|||||LINCOLN ROAD DISTRICT

**HISTORIC PRESERVATION BOARD
REVISED APPLICATION**

05/14/2024

LINCOLN ROAD DISTRICT IMPROVEMENTS PHASE 3

LINCOLN ROAD- 400 BLOCK
REVISED GATEWAY SIGN DESIGN (05/14/2024)

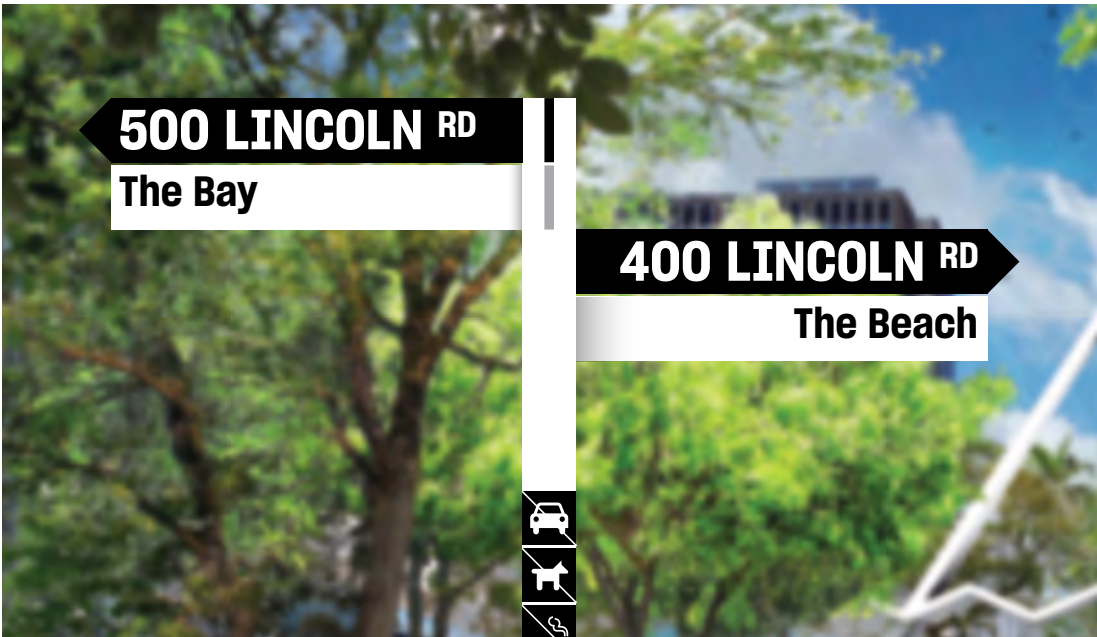
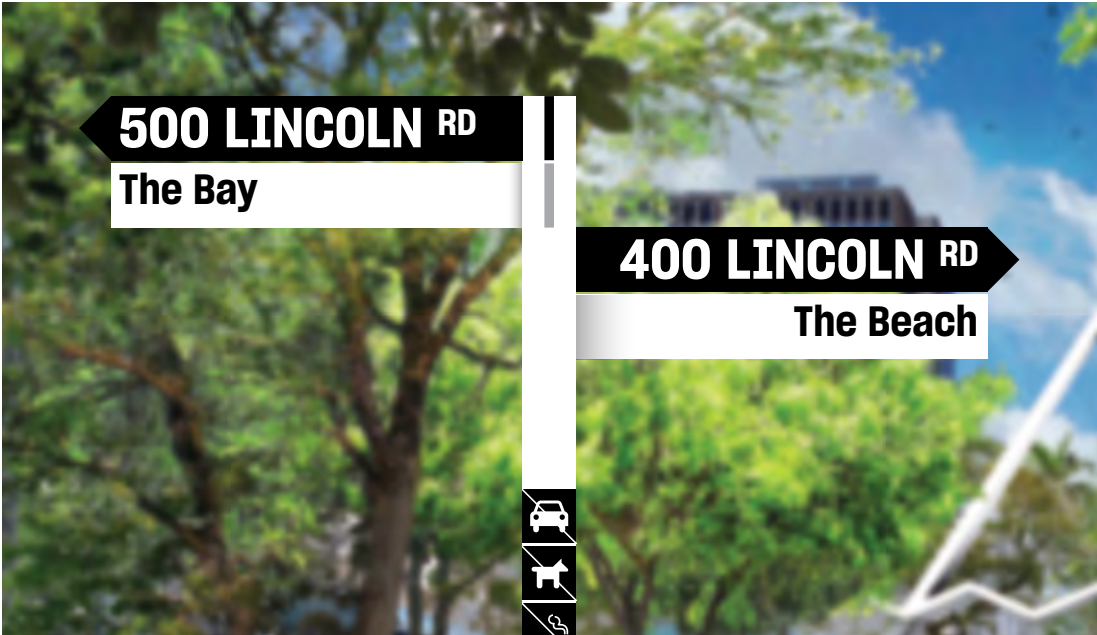
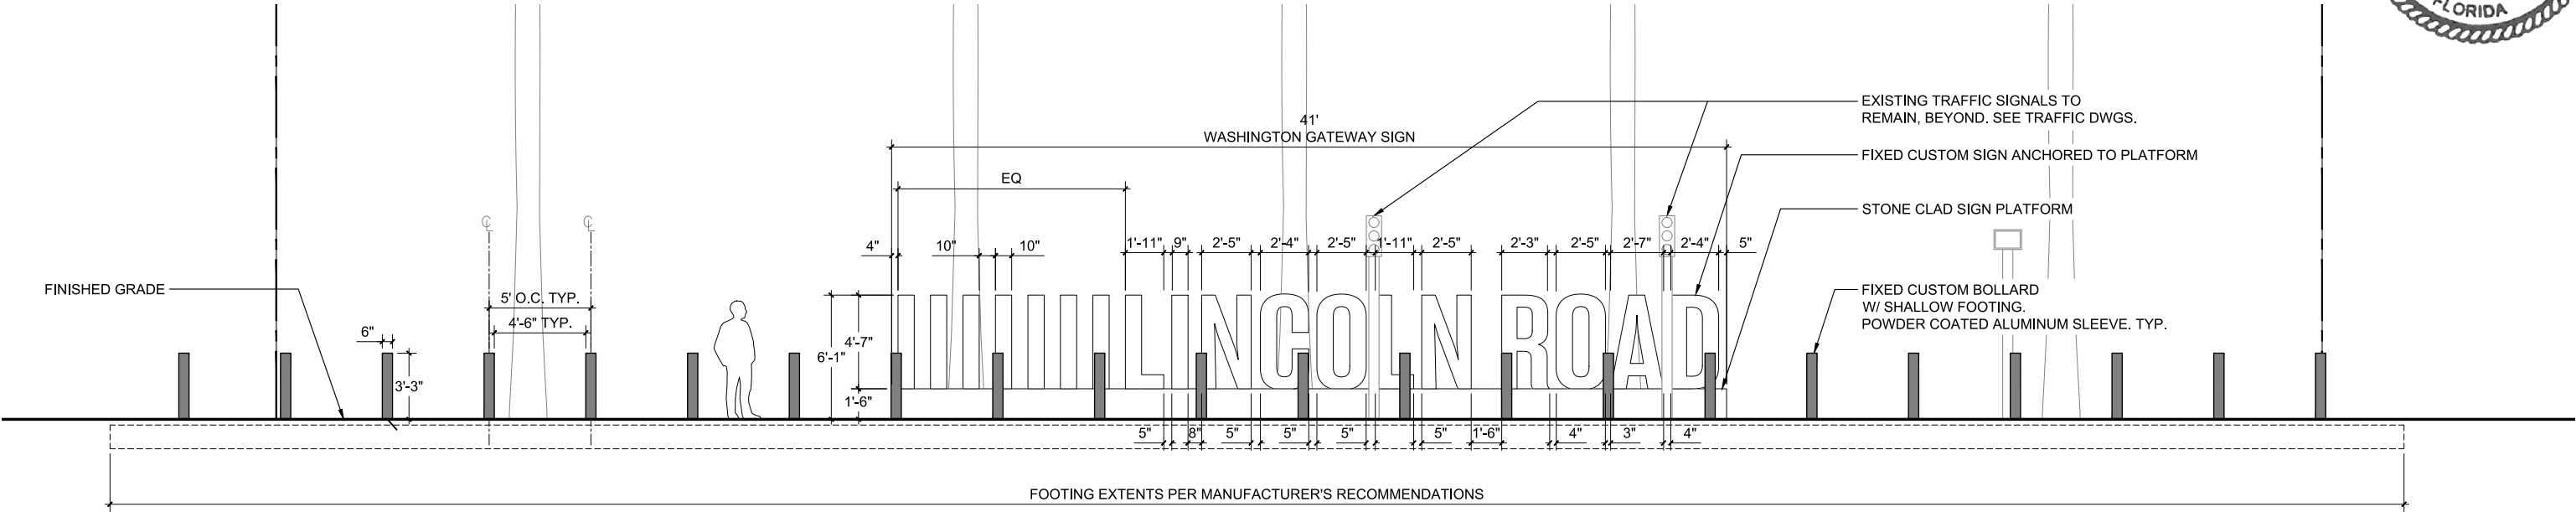
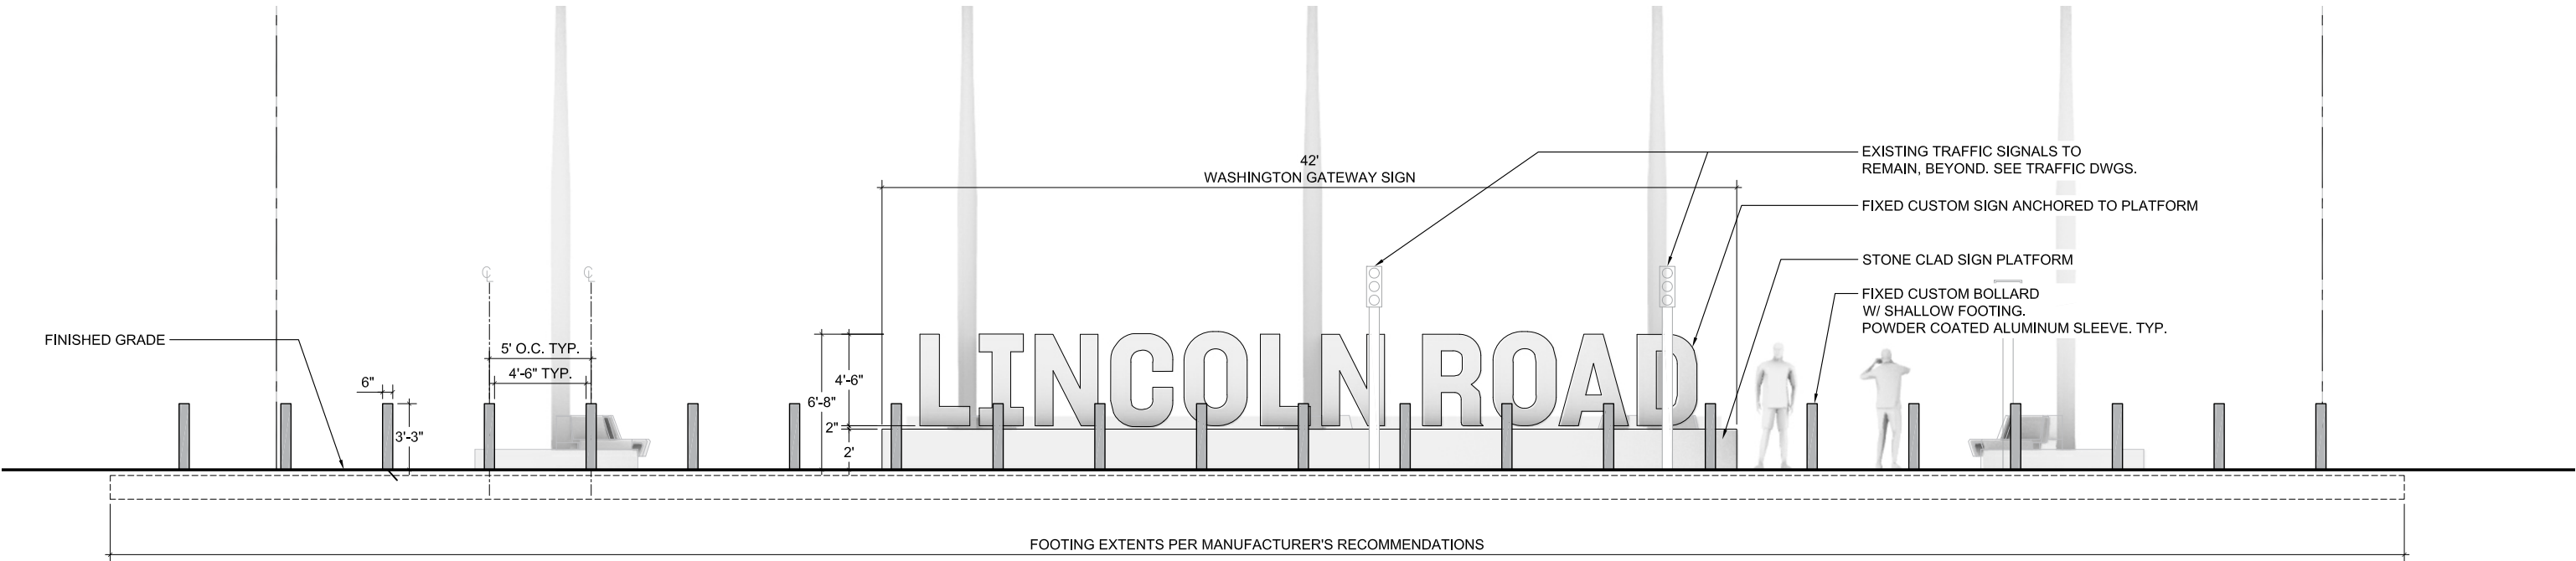
GATEWAY SIGN- REVISIT TO BETTER ALIGN WITH WAYFINDING TYPOGRAPHY

ELEVATION
PREVIOUS SIGN AT WASHINGTON AVENUE (02/13/2024)

ELEVATION
REVISED SIGN AT WASHINGTON AVENUE (05/14/2024)
